This service bulletin is applicable for all Tercel's gyrocopter.

## **SUBJECT**

Bowden flexible cable holder replacement.

<b>SERVICE BULLETIN</b>	30-07-21
		No. 01-21

Fig. 1

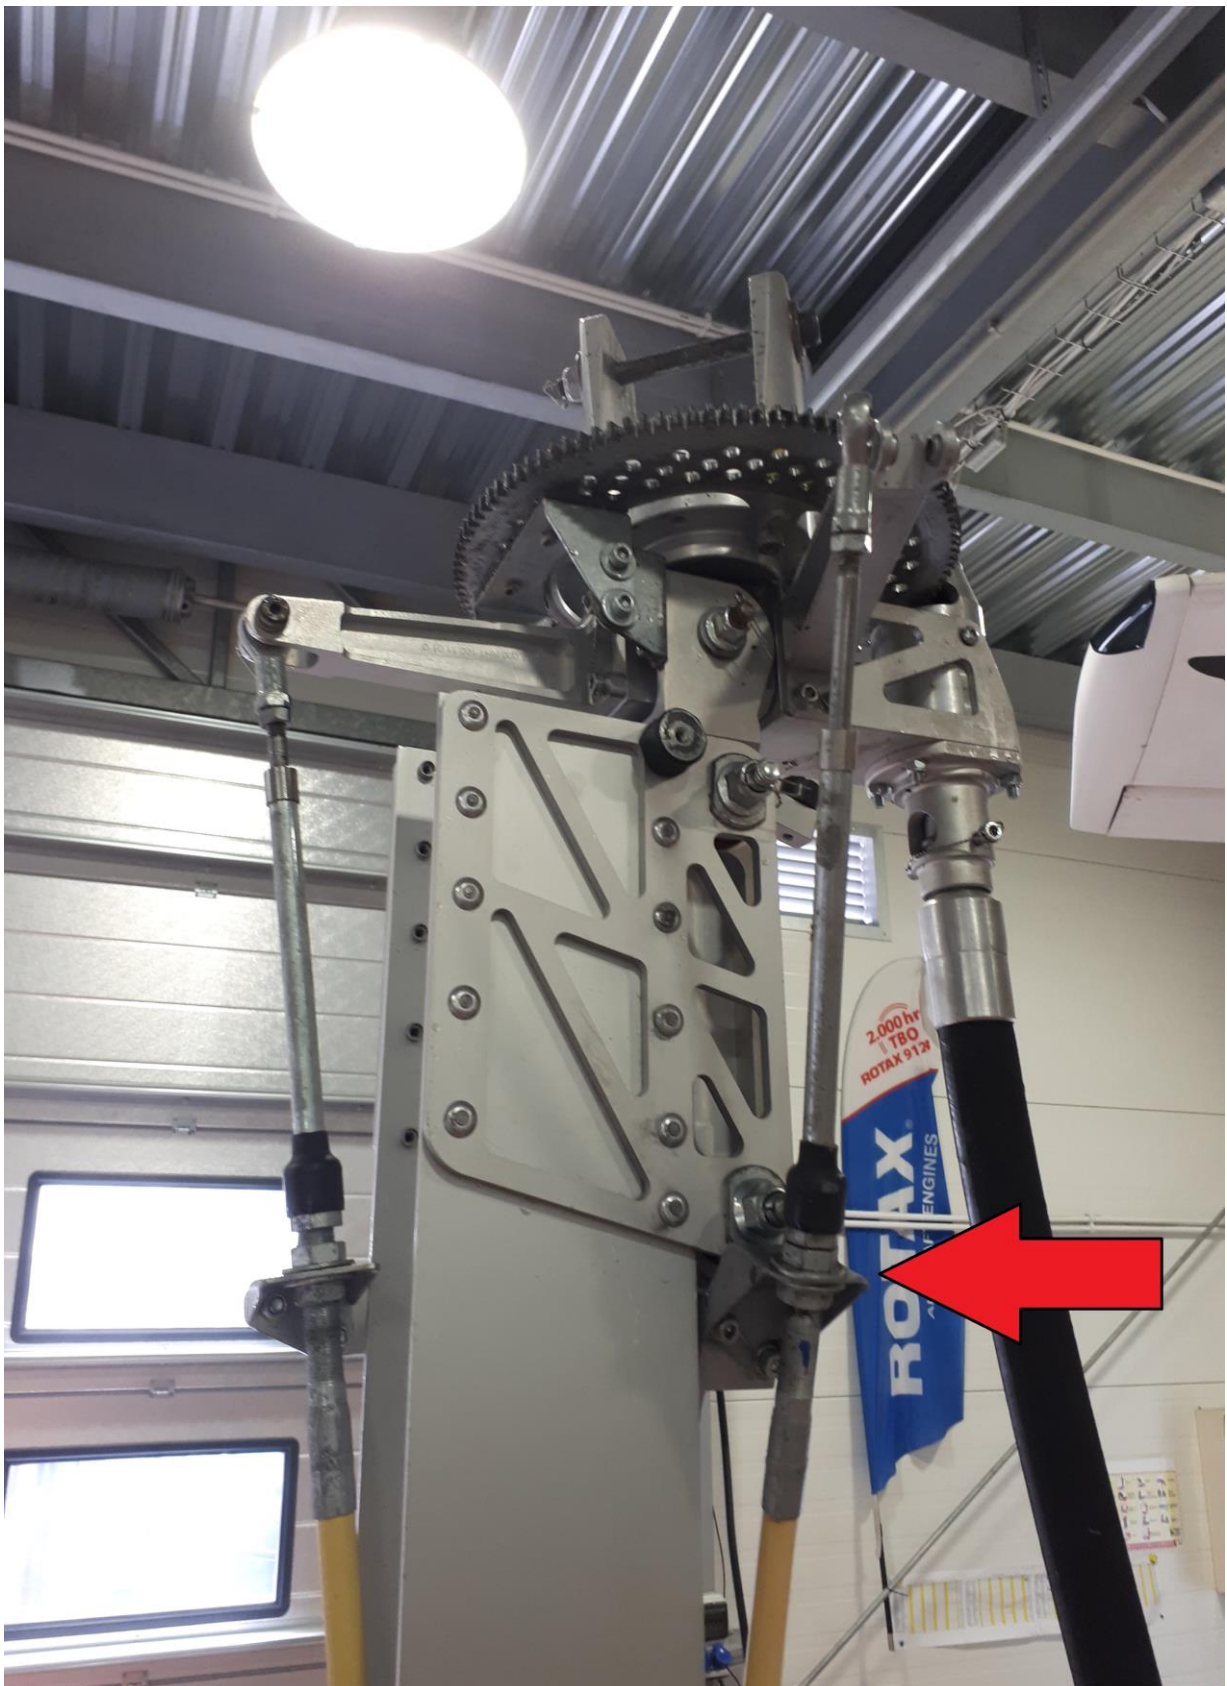
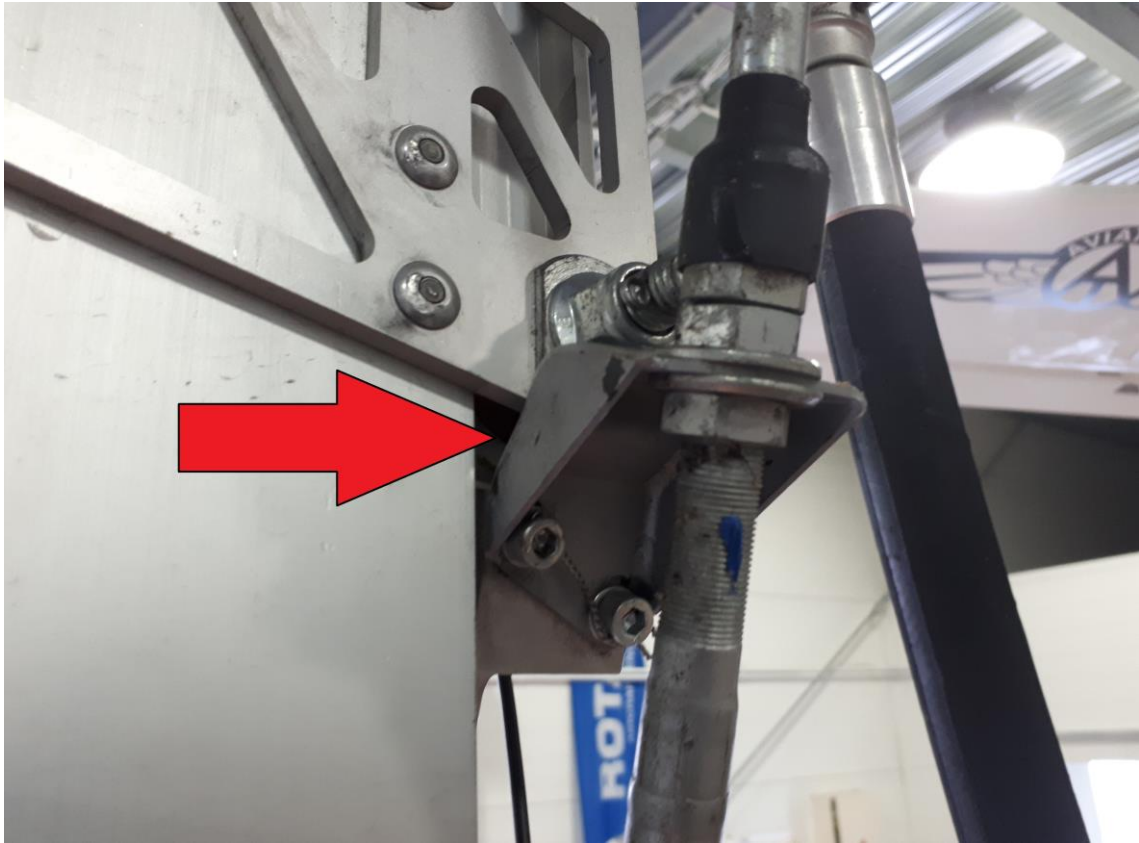
- 1) Check the holder in gyrocopter. Holder to be replaced is shown on pictures below [Fig. 1] and [Fig. 2].

**Holders without reinforced rib and additional hole have to be immediately replaced.**

There are two main differences between these holders: the new one has reinforcing rib and additional hole.

Fig. 3

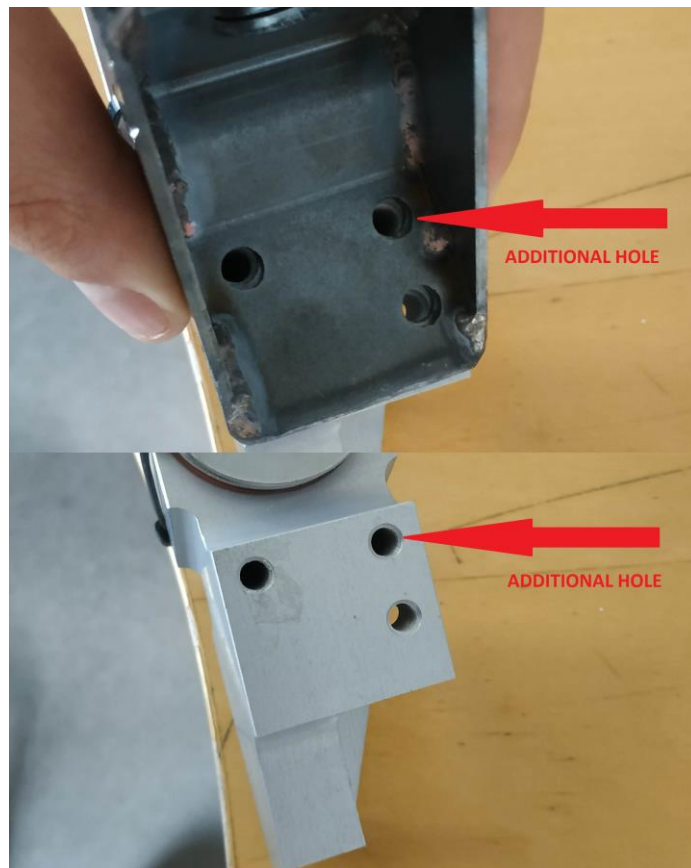
The new, improved holder requires drilling additional, 22 mm deep M6 threaded hole in the rotorhead holder shown on [Fig. 3].
